TWELVE MILE TOWNES JSP 25-03

Public hearing at the request of Singh Development, LLC for JSP 25-03 Twelve Mile Townes for Planning Commission's recommendation to the City Council for a Preliminary Site Plan with a PD-2 Option, Special Land Use, Wetland Permit, and Stormwater Management Plan approval. The subject property is located at the southeast and southwest corners of Twelve Mile Road and Twelve Oaks Mall access drive in Section 14. The applicant proposes utilizing the Planned Development 2 (PD-2) option to develop 125 townhome units.

Motion sheet

Figure 1. City of Novi Regulated Woodlands Map

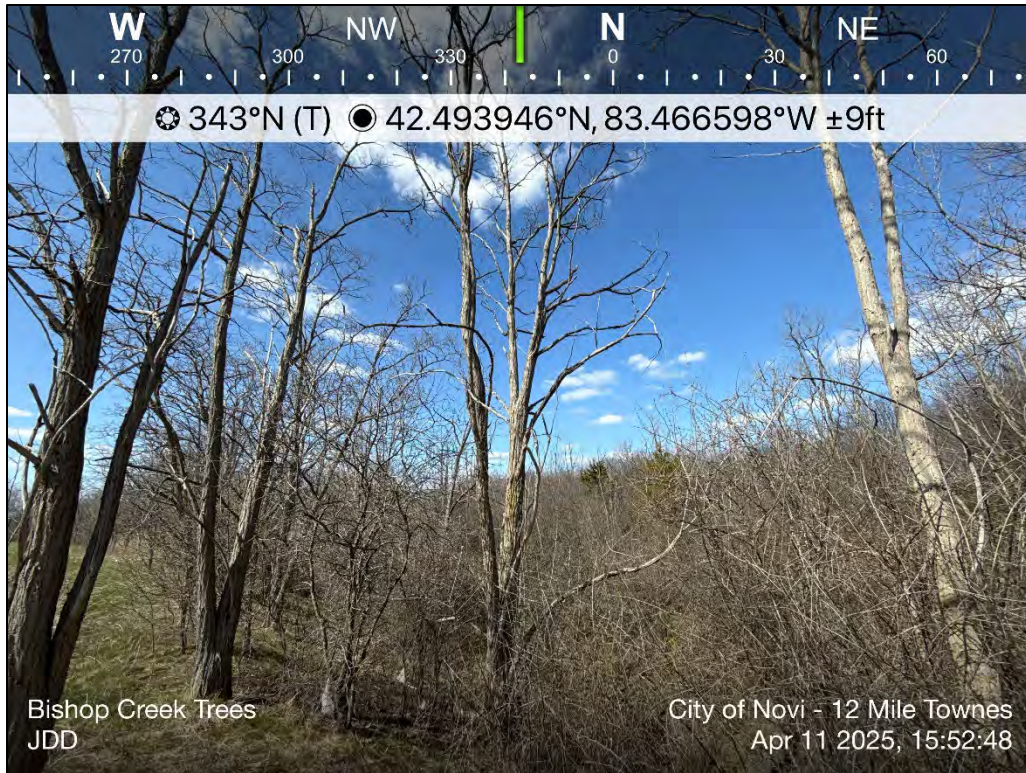
- Although no tree replacements are required on-site, it is recommended that remaining shrub and tree covered areas (identified on **Figure 1**) be preserved in a conservation easement for both woodlands and wetlands. If feasible, this will allow for the permanent shade cover of Bishop Creek (reducing water temperature) and continued growth of trees in this area. This may or may not benefit the proposed development in the form of additional future visual and sound screening between the existing 12 Oaks Mall and the proposed development.
